Subject: Response To Request For Additional Information –
License Amendment Request No. 287 Suppression Chamber to Drywell
Vacuum Breakers (TAC NO. MB2958)

Oyster Creek Generating Station (Oyster Creek)
Facility Operating License No. DPR-16
NRC Docket No. 50-219

**RESPONSE TO REQUEST FOR ADDITIONAL INFORMATION –
LICENSE AMENDMENT REQUEST NO. 287, SUPPRESSION CHAMBER
TO DRYWELL VACUUM BREAKERS**

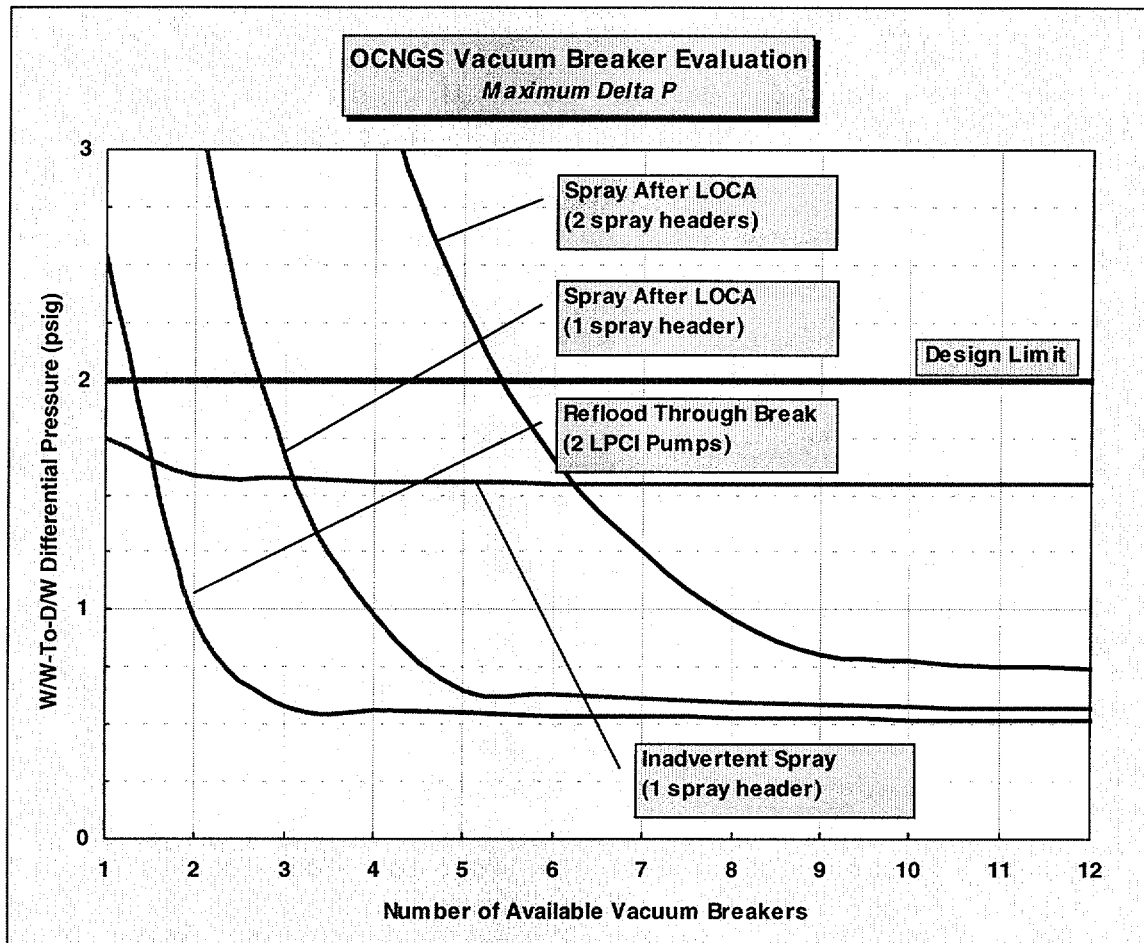
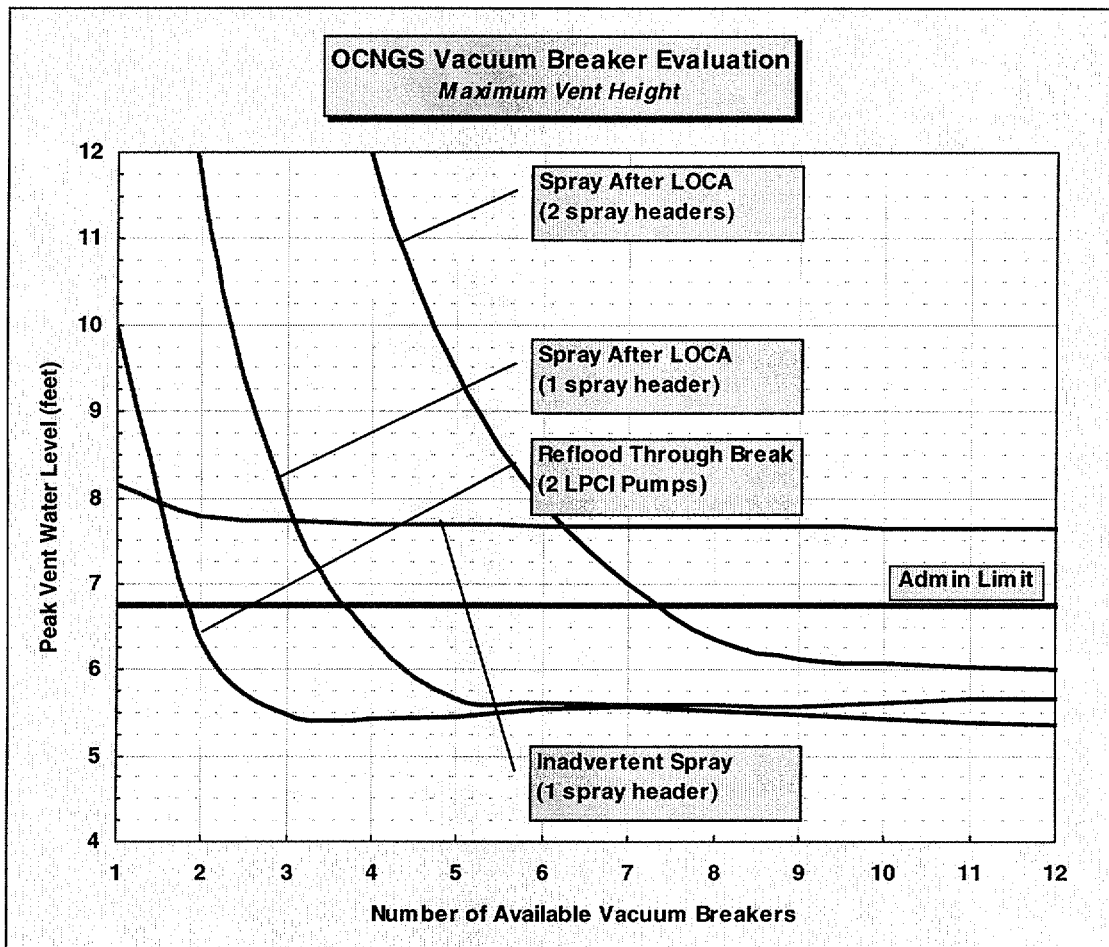
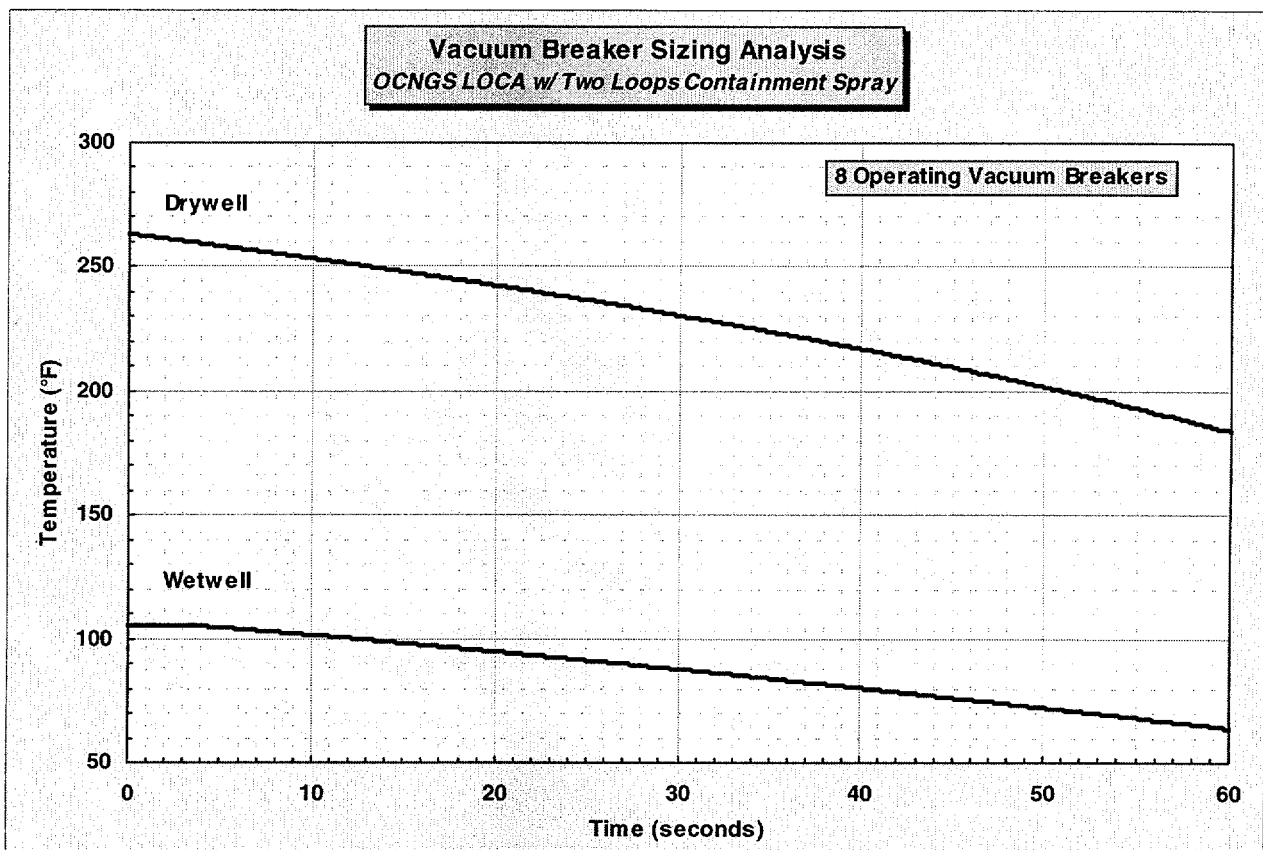
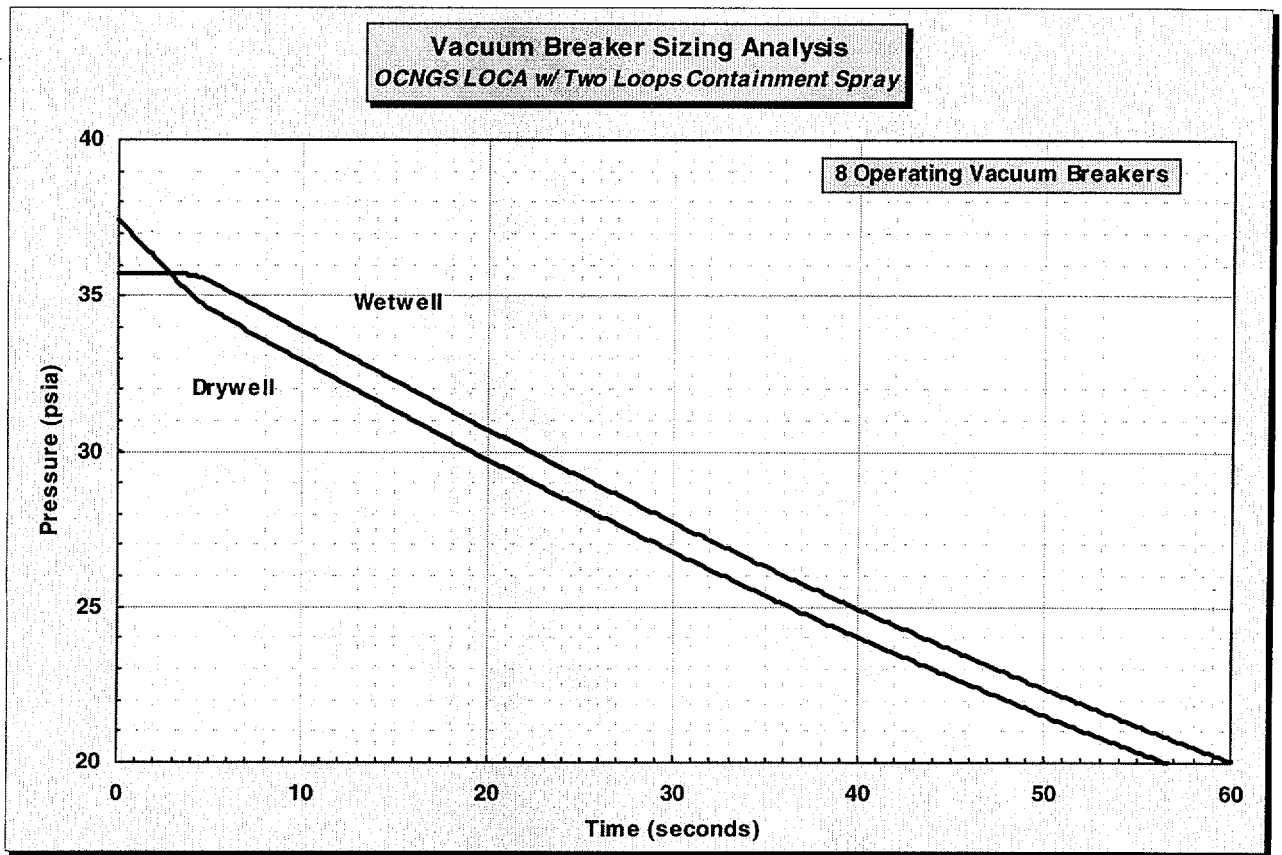
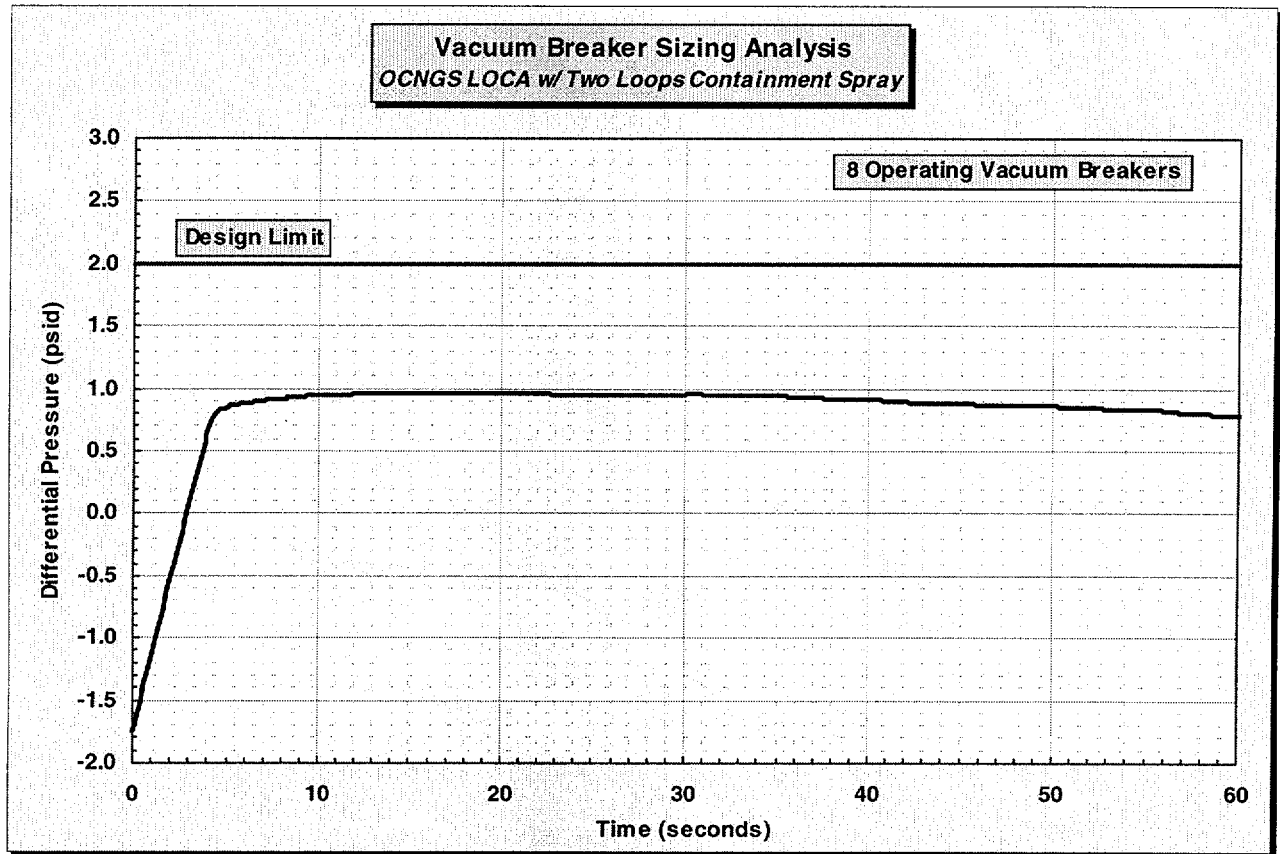
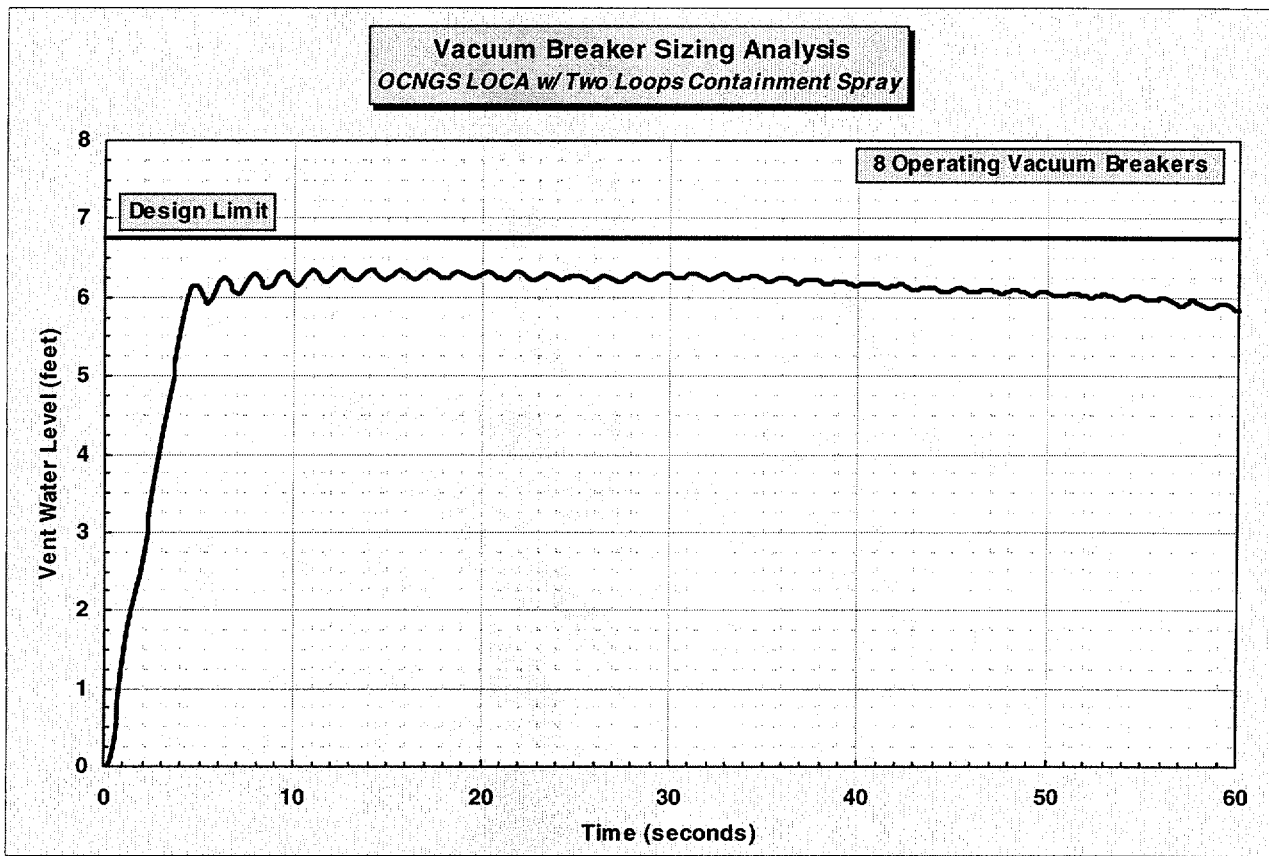
For the three cases considered, provide results of calculations showing the wetwell to drywell pressure as a function of the number of operable vacuum breakers and the peak vent water level as a function of the number of vacuum breakers. Also provide the results of calculations for eight vacuum breakers, showing the drywell and wetwell temperature versus time, the drywell and wetwell pressure versus time, the differential pressure between the wetwell and the drywell as a function of time and vent water level as a function of time.

Response

The following figures, extracted from the Oyster Creek analysis provide the requested results in graphic form. The results for eight vacuum breakers are provided for the most limiting case of LOCA with two loops of containment spray.

Figure 12

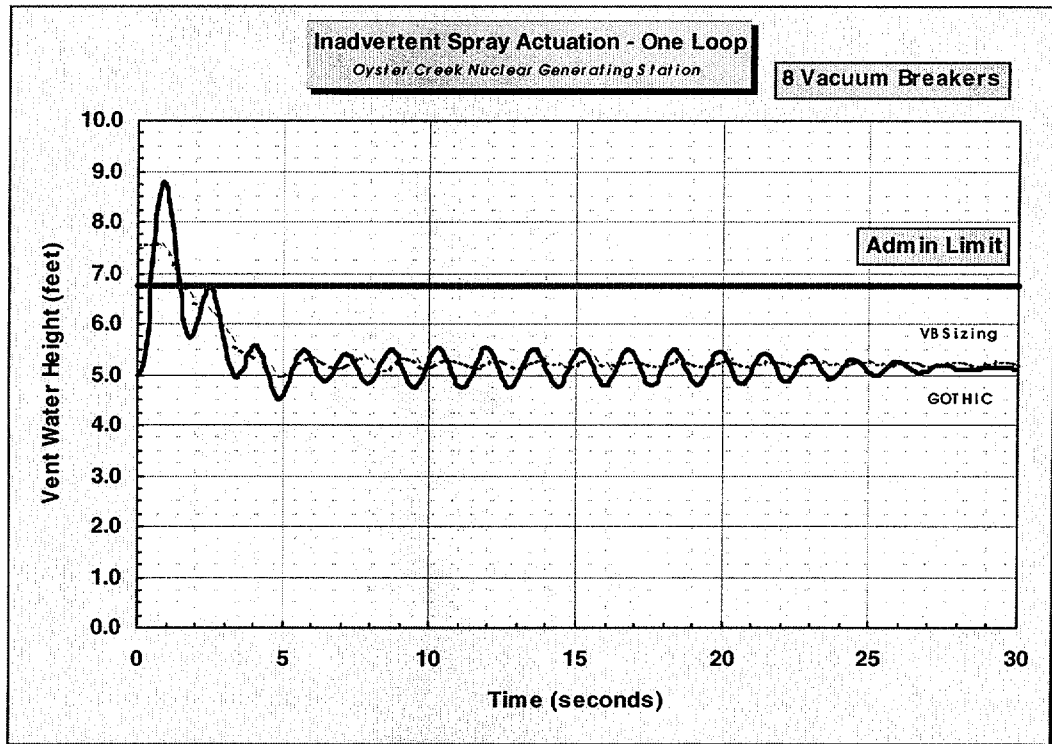
Page 2/9: If Bodega Bay tests, which “established the Oyster Creek design,” are the basis for requiring 12 vacuum breakers to be operable, justify the validity of calculations that predict that the differential pressure and downcomer level criteria can be satisfied with six vacuum breakers.

The figures on the following pages provide a comparison of the GOTHIC results (bold) with the VBSizing results (light and dashed), and indicate very good comparison. The only significant deviation between the two results is for the initial peak in vent water height for the ISA case. For this figure (Figure 12), GOTHIC indicates a higher vent water height than VBSizing. This is attributed to the assumption in the VBSizing code that the initial conditions are stagnant, i.e., the vent water column velocity is initially set to zero. For the ISA case, the VBSizing code begins at some small time just following initiation of sprays, when the containment has become saturated. However, for this case the pressure in the drywell has rapidly dropped and the water column rises quickly such that the velocity (momentum) of the water column at saturation is enough to cause the column to continue to rise, even though the differential pressure no longer supports the height. Because VBSizing assumes the initial column velocity is zero, it cannot appropriately determine this initial peak height. The GOTHIC analysis, however, because it can begin at the true event initiation, with non-saturated conditions in the drywell, and because it models the column momentum, appropriately estimates the peak water column height. However, the vent water column height is not of any significance for Oyster Creek because the vacuum breakers are located externally and are not affected by the water column height.
